# VP-25Wx Release Notes

## What OS version is applicable to which hardware version?

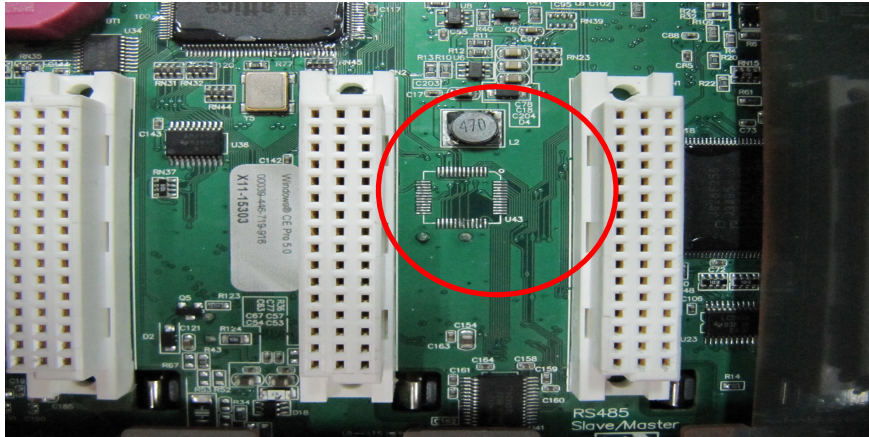
<b>Hardware Version</b>	V1.5 or earlier	V1.7	V1.9 or later
<b>Eboot/OS Version</b>			
Eboot (Ver. 1.0.1.1 and earlier)	Ok	N/A	N/A
Eboot (Ver. 1.1.0.1 and later)	Ok	Ok	Ok
OS (Ver. 1.1.0.1 and earlier)	Ok	N/A	N/A
OS (Ver. 2.0.0.2 and earlier)	Ok	Ok	N/A
OS (Ver. 2.1.0.0 and later)	Ok	(Note5)	Ok

1. V1.5 hardware or earlier is equipped with the **Intel J3 Flash Chip (95ns)**
2. V1.7 hardware is equipped with the **Samsung K8 Flash Chip (70ns).**
3. The Touch/Audio chip on V1.7 hardware or earlier is equipped with the **USB1400** chip.
4. The Touch and audio chips on V1.9 hardware or later are equipped with the **PM6000** and the **AIC33** chips.
5. Booting ok, touch panel doesn't work, audio doesn't work.

As older typed of chips are phased out, earlier OS versions will no longer be applicable to the new hardware. However, the latest OS version will be suitable for all hardware versions, so it is recommended that you install the appropriate OS versions to match the hardware, otherwise you may have problem with your VP-25Wx.

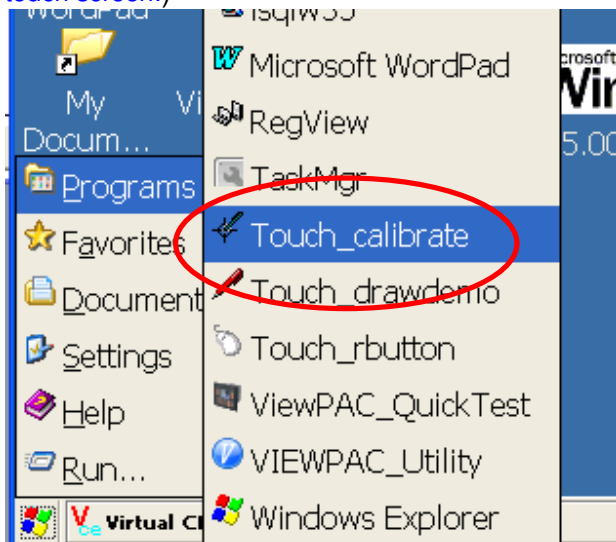
Because the UCB1400 touch chip has been phased out, the chip in the VP-25Wx has been replaced with a PM6000 touch chip.

**Step 1:** Click Start->Programs->Touch\_calibrate (If the [Touch\\_calibrate.exe utility doesn't execute](#), it means that the hardware is old. Please refer to section 8 in [ViewPAC\\_25w1\\_quick\\_start\\_guide\\_english\\_v1.0.2.pdf](#) file for details of recalibrate the touch screen.)

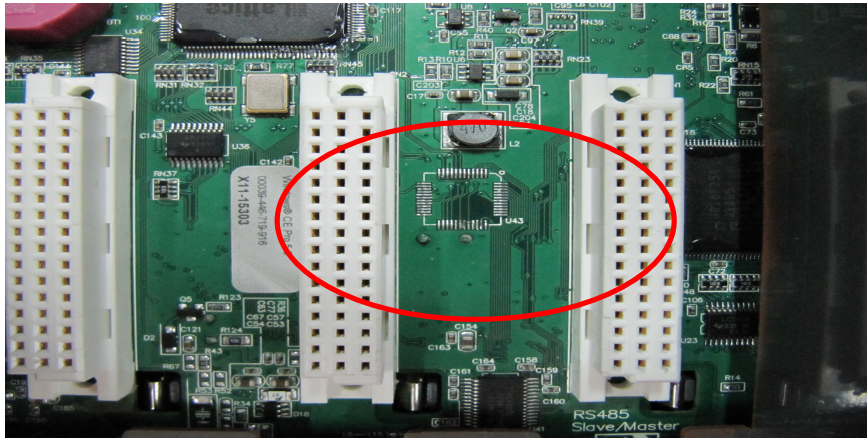
<b>Hardware Version</b>	<b>V1.5 or earlier</b>	<b>V1.7</b>	<b>V1.9 or later</b>
<b>Eboot/OS Version</b>			
Eboot (Ver. 1.0.1.1 and earlier)	Ok	N/A	N/A
Eboot (Ver. 1.1.0.1 and later)	Ok	Ok	Ok
OS (Ver. 1.1.0.1 and earlier)	Ok	N/A	N/A
OS (Ver. 2.0.0.2 and earlier)	Ok	Ok	N/A
OS (Ver. 2.1.0.0 and later)	Ok	(Note5)	Ok

1. V1.5 及更早版本的硬體其 Flash 是搭配 **Intel J3 Flash Chip** (95ns)
2. V1.7 硬體其 Flash 是搭配 **Samsung K8 Flash Chip** (70ns).
3. V1.7 及更早版本的硬體其 Touch 及 Audio 晶片是使用 **USB1400**
4. V1.9 及以後版本的硬體 其 Touch 及 Audio 晶片各是使用 **PM6000** 及 **AIC33**
5. 可以開機，但觸控螢幕及音效無作用。

因零件汰換，對於新版的硬體，舊版的 OS 已不適用，新版的 OS 則可向下相容，請依照表格安裝對應的 OS，否則將會出現不可預期的問題。

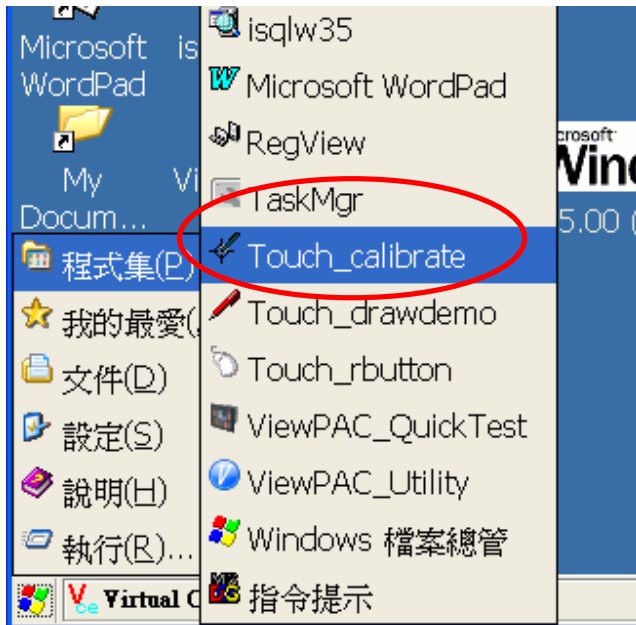
由於觸控晶片 UCB1400 停產，因此更換觸控晶片為 PM6000，以下為 PM6000 觸控晶片的校正使用方法：

**Step 1:** Start->程式集->Touch\_calibrate(如果校正程式無法執行，表示為舊版硬體，請參考 [ViewPAC\\_25w1\\_quick\\_start\\_guide\\_chinese\\_v1.0.2.pdf](#) 文件中的第八項，進行觸控校正)
